SITE SUPPLEMENTAL INSTRUCTION

PROJECT: Forestside Estates
Attmar & Palleschi Drive
Brampton, ON

SITE SI NO. M-7

PURPOSE: To revise make-up air risers to suit space requirements & City Permits comments.

DRAWN MC	CHECKED LM	SCALE 1:50
DATE MAY, 2019	PROJECT 18-017	DRAWING M-37A OF -

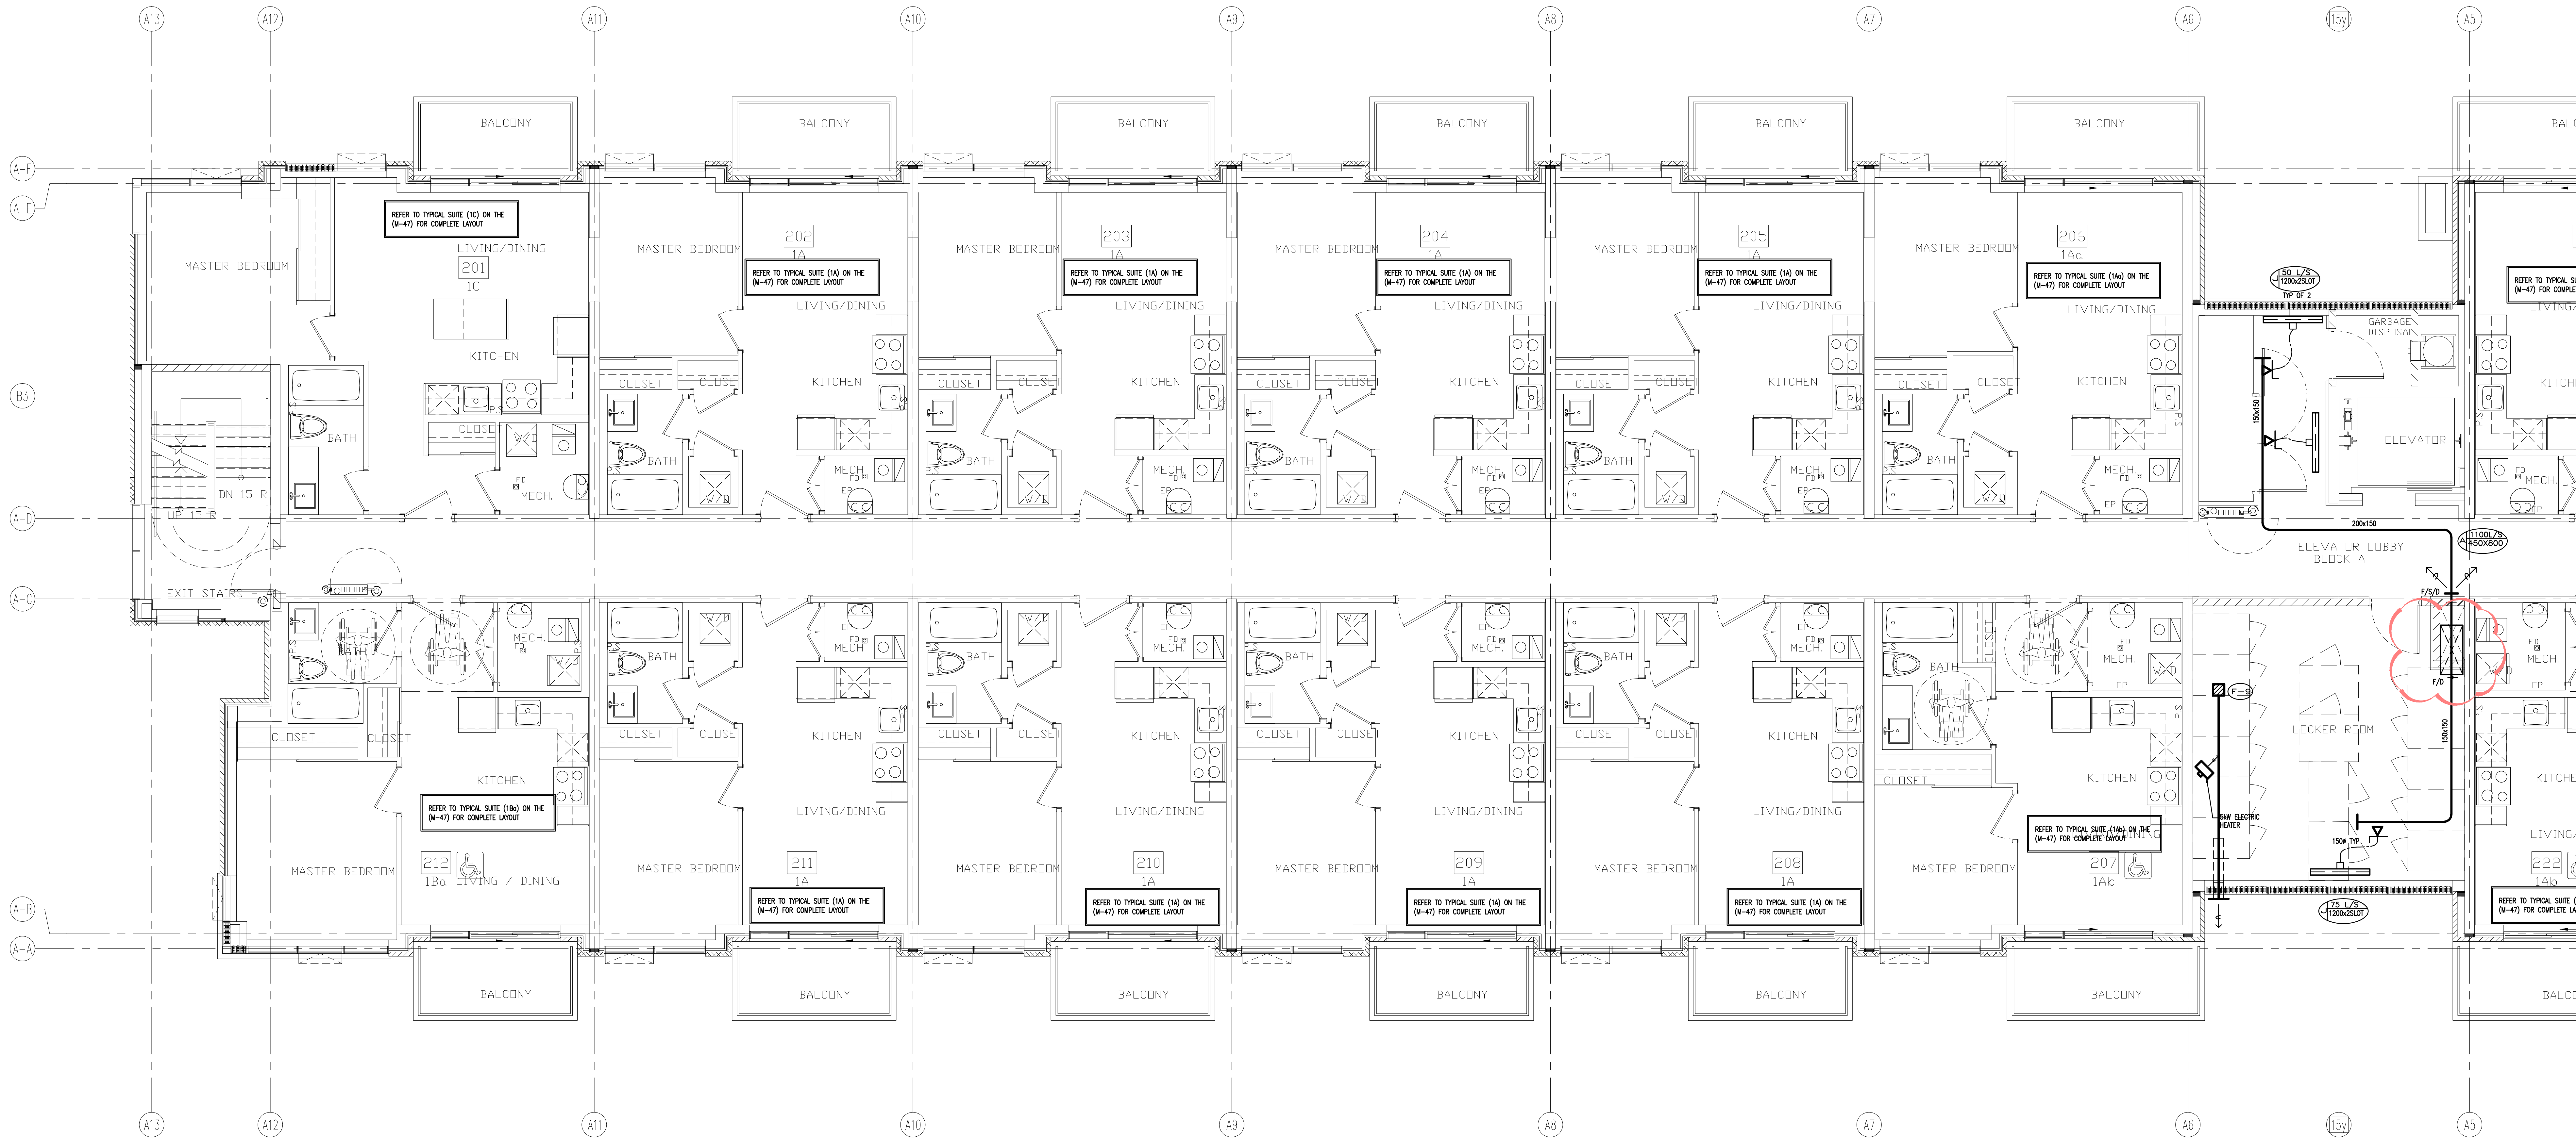
15.1 Relocate: Make-up air riser.
Locate make-up air riser 600mm.
Back from face of corridor wall (cut floor).

DRAWN MC	CHECKED LM	SCALE 1:50
DATE MAY, 2019	PROJECT 18-017	DRAWING M-39A OF -

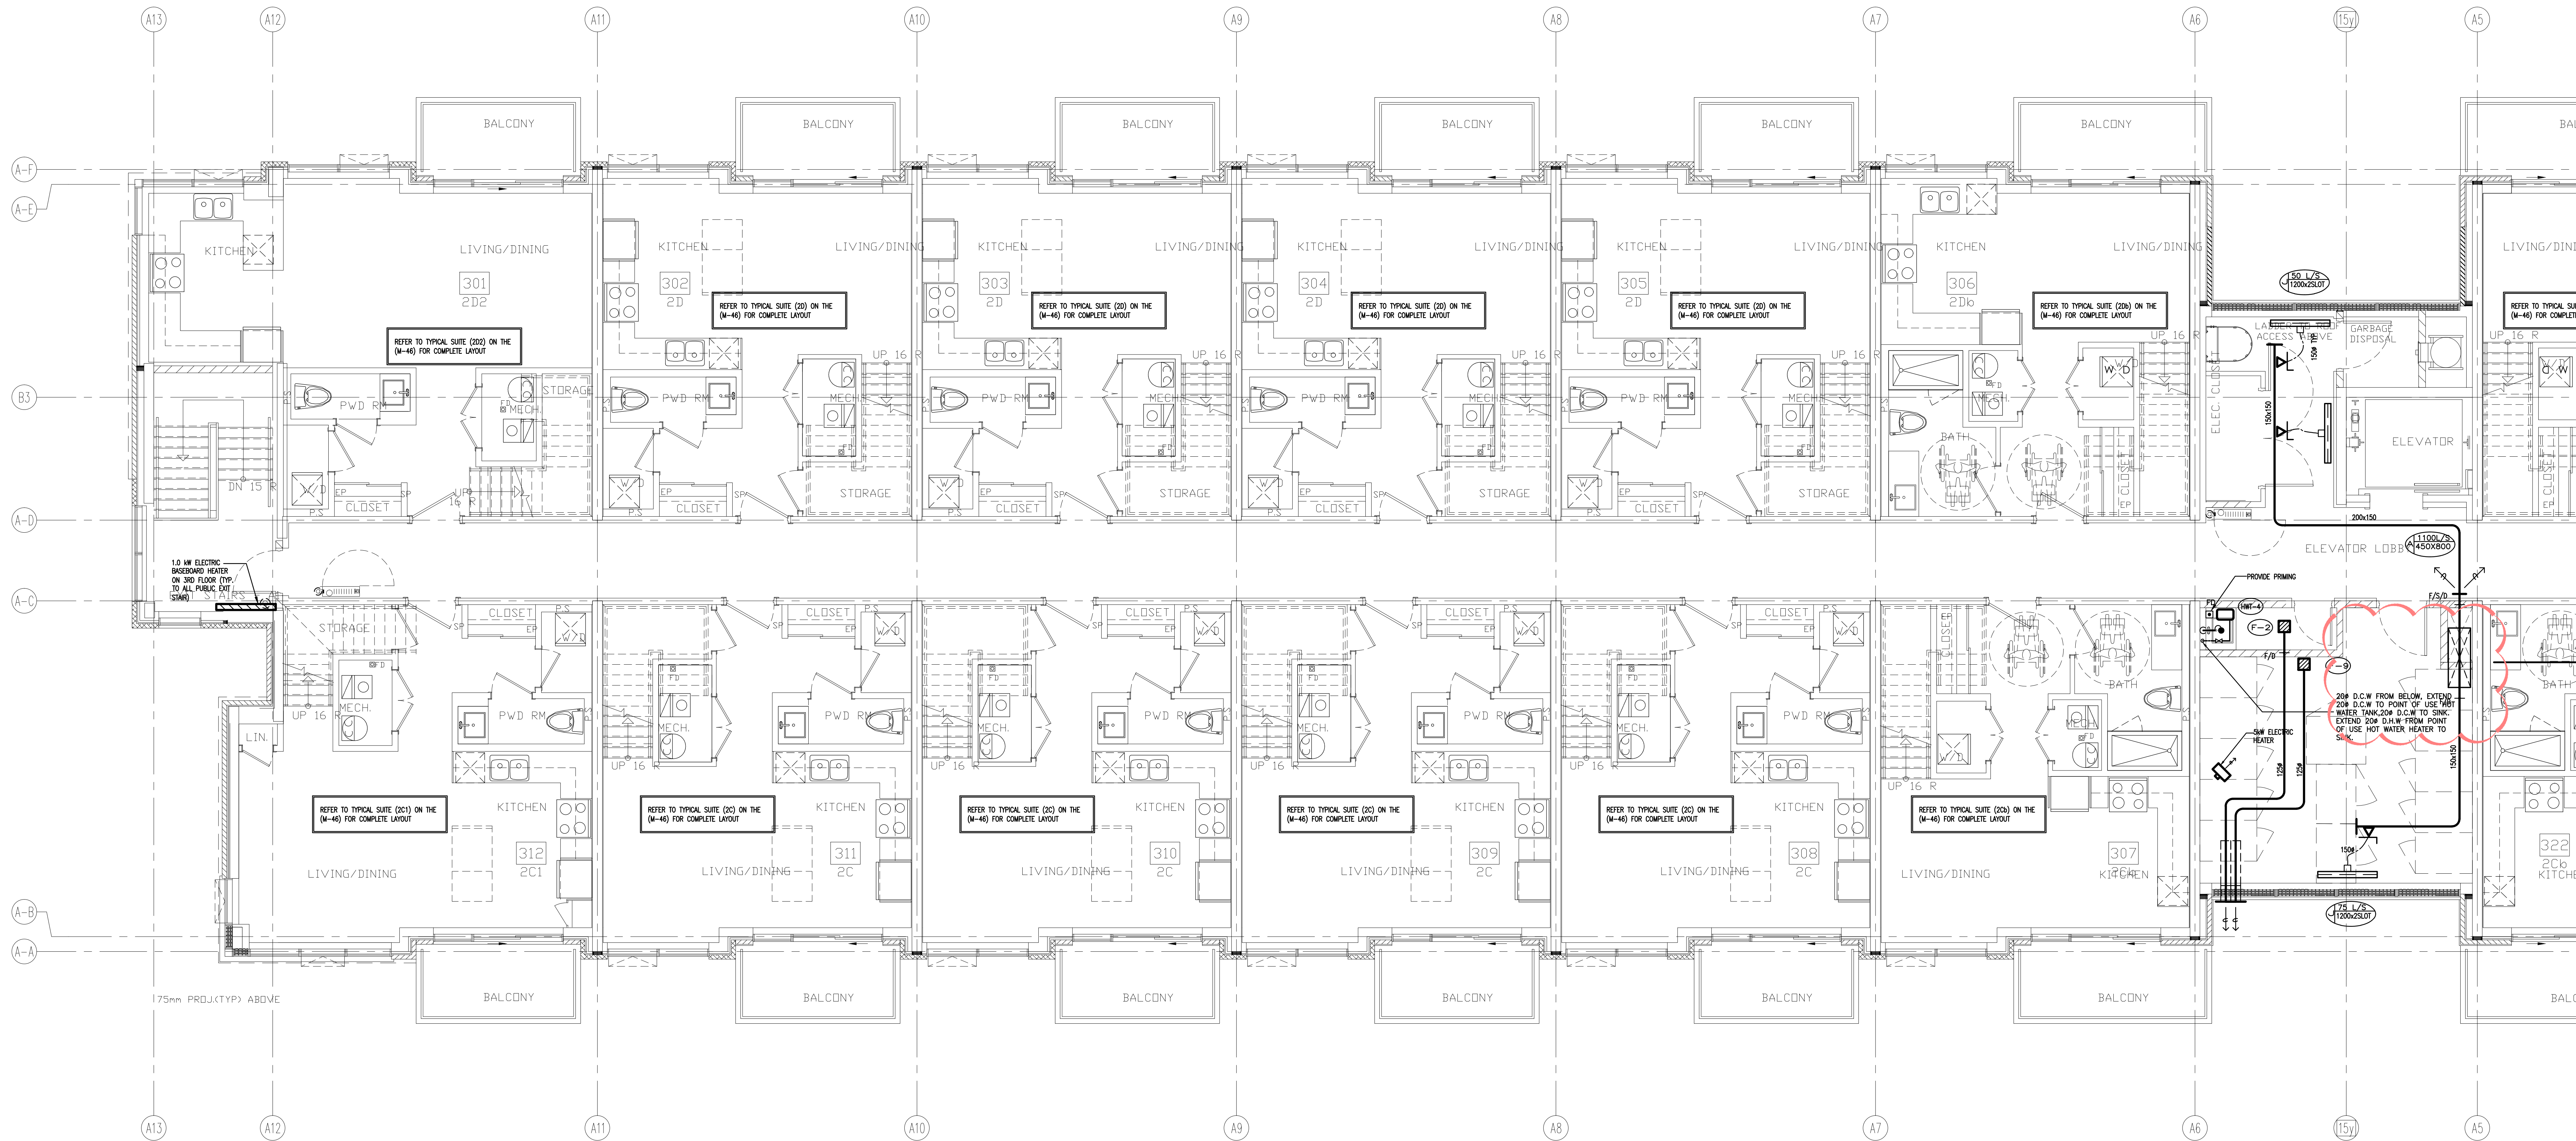
16.1 Relocate: Make-up air riser.
Locate make-up air riser 600mm.
Back from face of corridor wall (cut floor).
